Service-Information Motorcycle

46 031 91
(2448)

R100GS/R100GS P-D Saddlebag Mounts - 1991 Models

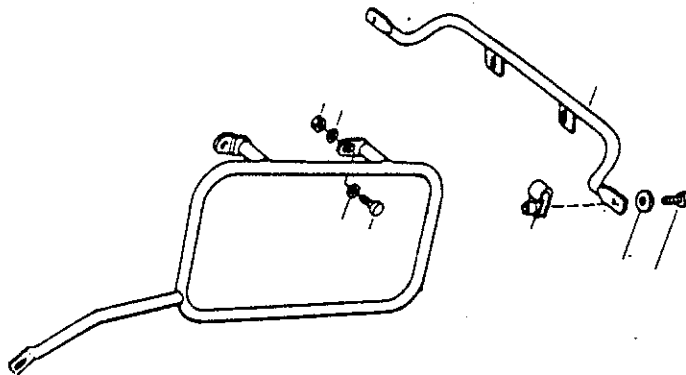
The R100GS P-D is manufactured with saddlebag mounts installed during production. The mounts are chrome plated so that they are more corrosion-resistant. A noticeable change this year is the new Matte Black cross support which improves the strength of the saddlebag mounts in rough-duty applications:

72 60 2 315 680 - Case Rod Chrome

72 60 2 315 678 - Case Rod Black

If your customer chooses to install saddlebag mounts, the new cross support must also be installed.

The cross support may also be fitted to 1988, 1989, and 1990 models at the owner's expense, with particular benefit during rough-duty applications.
